EDGEWATER HEIGHTS SUBDIVISION

ELLINGTON, CONNECTICUT

REPORT

Review Date: APRIL 14, 1987

PLAT PLAN SHEET INDEX
SCALE: 1" = 200'

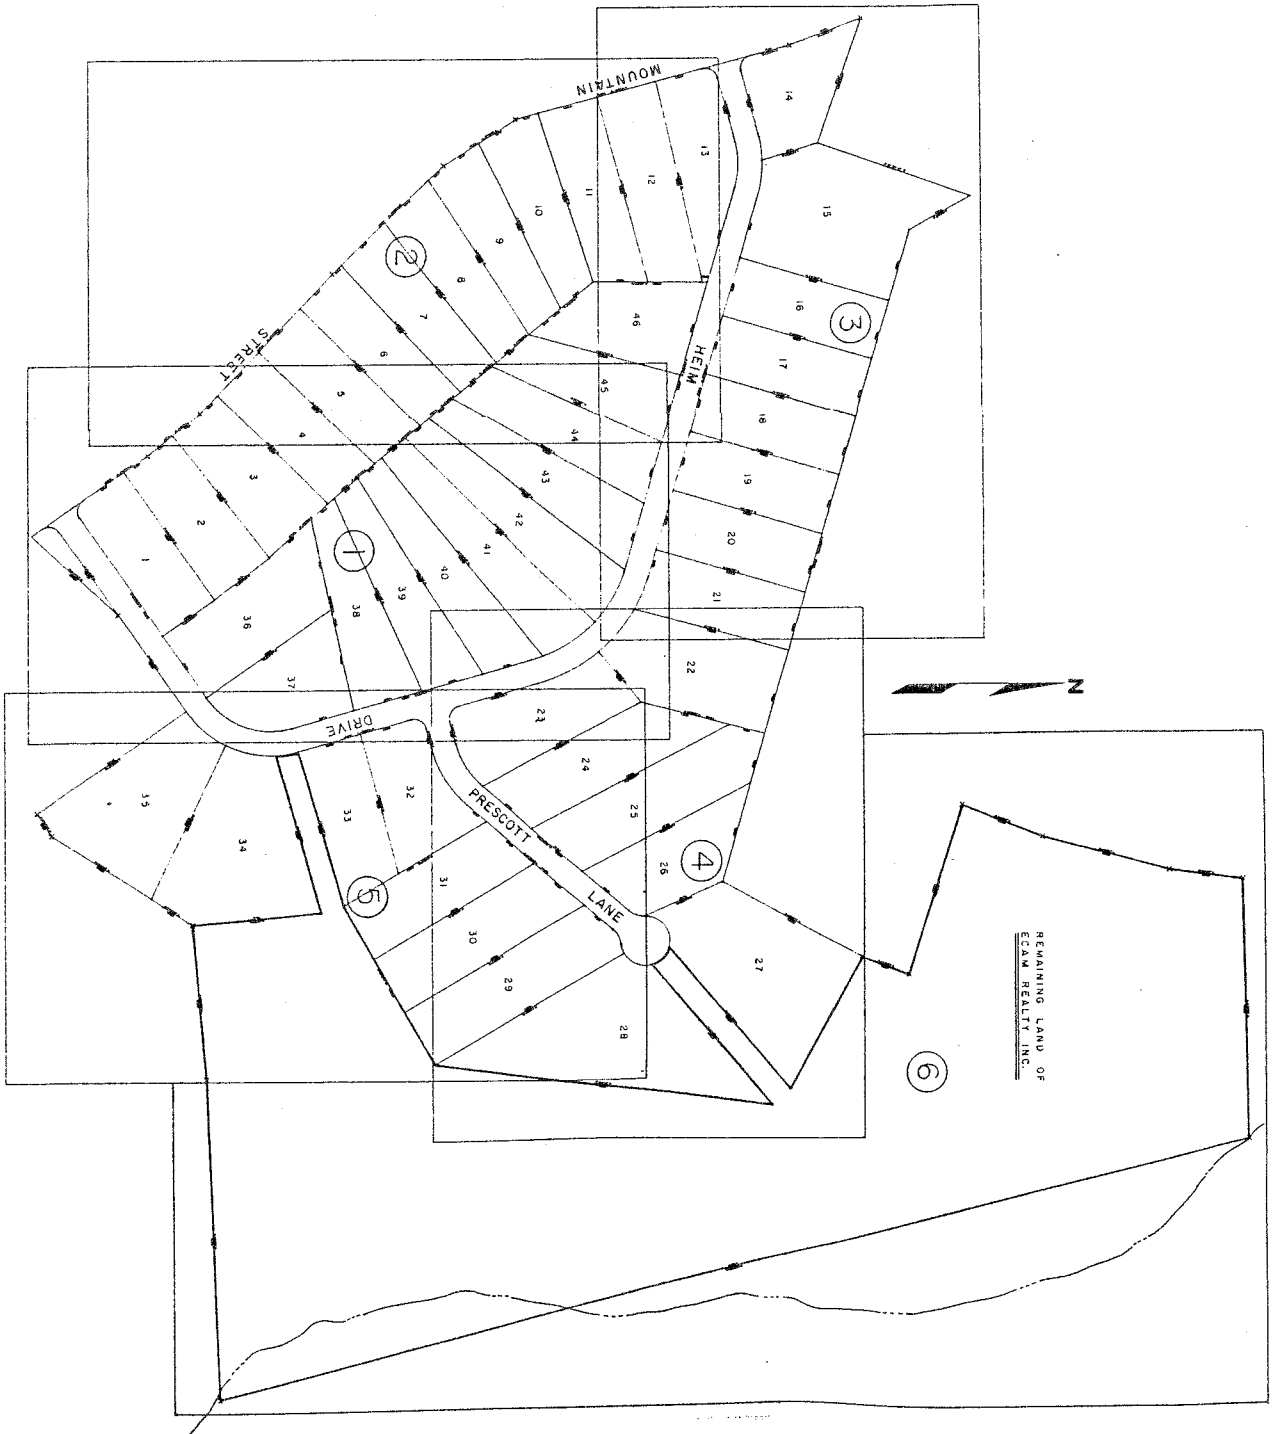
1. Wetland boundary information as provided on the plan map was not verified in the field since most of the flags were missing and the numbers were not legible on the few remaining flags. The consulting soil scientist should review the plans and sign them certifying that the wetland boundary information presented is substantially correct. The date(s) when the field work was done should also be included on the plan.

2. The intermittent stream running from the existing pond on lot number 35 and wetlands under the proposed southern entrance of Helm Drive were not surveyed onto the plan map.

4. The plans call for direct discharge of stormwater into the intermittent stream. Sediment control to collect silt, road sand and debris from being discharged into the stream should be addressed.

6. An Operation and Maintenance Plan should be developed for the sediment basin and the responsibility of cleaning and maintaining it should be indicated on the plan map.

7. Homes and driveways were not shown on the plan map. Placement should take into account the proximity to wetlands, steep topography and minimum areas of buildable land. Without knowing the exact placement of homes and driveways on each lot, the degree of wetland disturbance to install driveways and to connect laterals to the sewer line is unknown. It appears that driveways on lots 15 and 16 will have to cross the wetlands and that lots 1 through 16 and lots 42 through 46 will have to excavate into the wetlands to connect to the sewer line.

13. The Erosion and Sediment Control Plan that was submitted is not adequate. The plans should show the measures listed in the narrative and details shown. Maintenance of Erosion and Sediment control measures should be listed as necessary. The seeding dates are incorrect and should be April 15 through June 15 and August 15 through September 15. A more detailed plan should be developed. The District would appreciate the opportunity to review revised plans for Erosion and Sediment Control for adequacy prior to final approval.
